ARCHITECTURAL ADVISORY COMMITTEE MEMORANDUM

SUBJECT: REQUEST BY CRAIG BOUMAN, ON BEHALF OF GREENSKEEPERS, LLC, FOR MINOR ARCHITECTURAL REVIEW APPROVAL TO ALTER THE EXTERIOR ELEVATIONS OF AN EXISTING COMMERCIAL BUILDING AND INSTALL A NEW WALL SIGN FOR A NEW CANNABIS DISPENSARY, HITS STUDIO, LOCATED AT 155 SOUTH PALM CANYON DRIVE SUITE A1 (APN: 513-143-019), ZONE CBD, SECTION 15 (CASE NO. 3.1437 MAA & CASE NO. 20-045 SI). (NK)

CHANNEL LETTER - TYPICAL SECTION - REVERSE-LIT

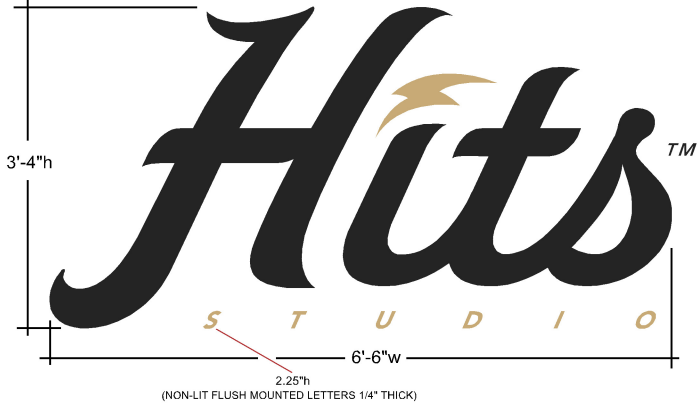
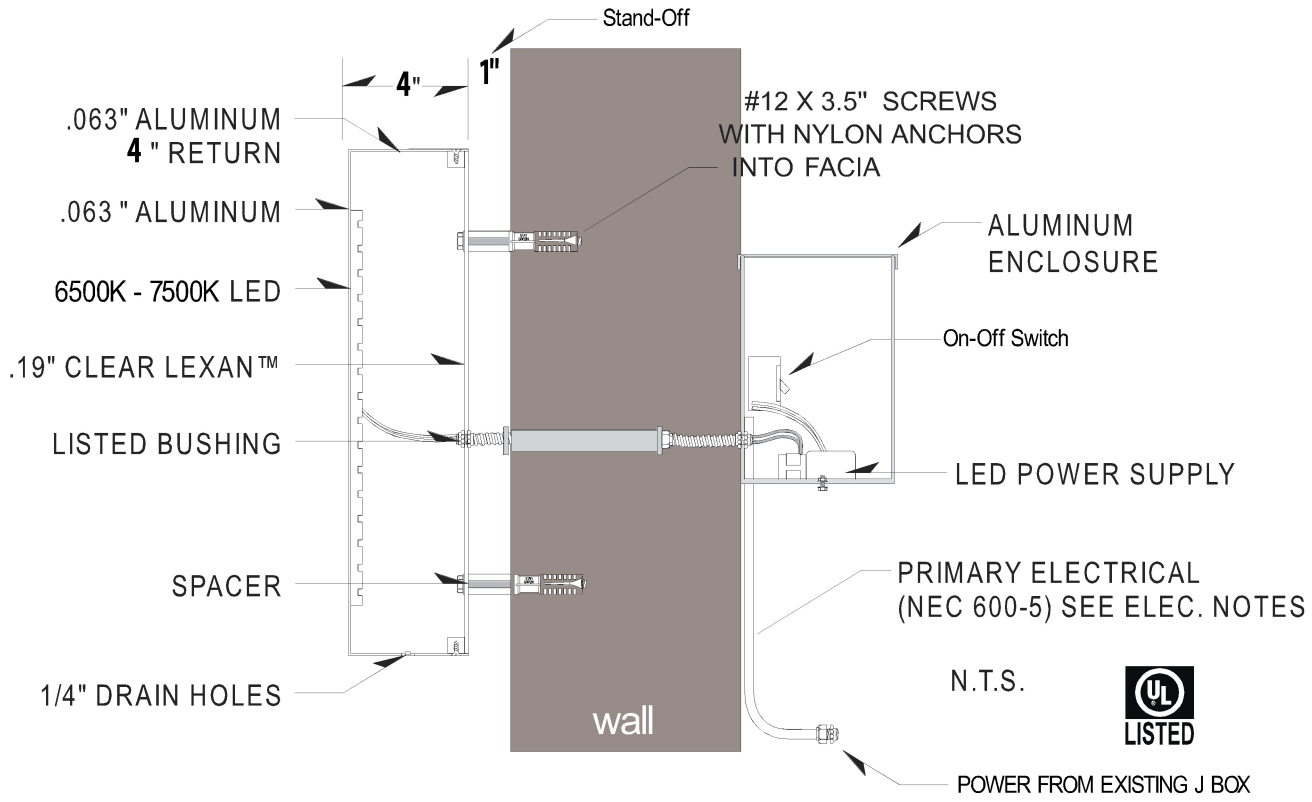
3. The Mercado Plaza Sign Program does not specify the maximum allowable sign height for the project site, and the proposed 40-inch sign height is greater than the average sign height found on the Mercado Plaza Palm Canyon Drive elevation.

Pursuant to the City of Palm Springs Downtown Urban Design Plan, “*Signs should complement the architecture of the building and also provide a unifying element along the streetscape*” (Downtown Urban Design Plan, page 52). The Mercado Plaza Sign Program does not specify the maximum allowable sign height for the project site. Based on the Sign Permit application records for the businesses located on the Palm Canyon Drive frontage at the Mercado Plaza, the average wall sign height is approximately 26.5 inches. The proposed sign is 40 inches in height, it is greater than the average sign height.

5.	<p><i>Signs and graphics, as understood in architectural design including materials and colors.</i></p> <p>While the proposed wall sign meets the applicable Sign Program regulations including design, materials, and colors, the proposed 40-inch sign height is greater than the average sign height (26 inches) found on the Palm Canyon Drive frontage at the Mercado Plaza.</p>	N

1. Choose warmer color palette, which is more compatible with the colors that are applied to the existing building.
2. Reconsider the removal of the existing stone veneer and base trim.
3. The proportion of the proposed wall sign relative to the background field shall be consistent with the submitted rendering (Sheet A6.0, '5 – Proposed Design'); reduce the sign size as needed to meet this requirement.

5 - PROPOSED DESIGN

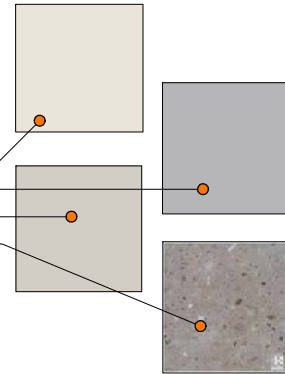
1. The proposed cooler color palette makes the project site appear detached from the rest of the building.
2. Removal of the existing architectural details such as the window on the south elevation and stone veneer on the columns and base trim simplifies the façade of the tenant space which is a part of a Spanish/Mediterranean-style building.
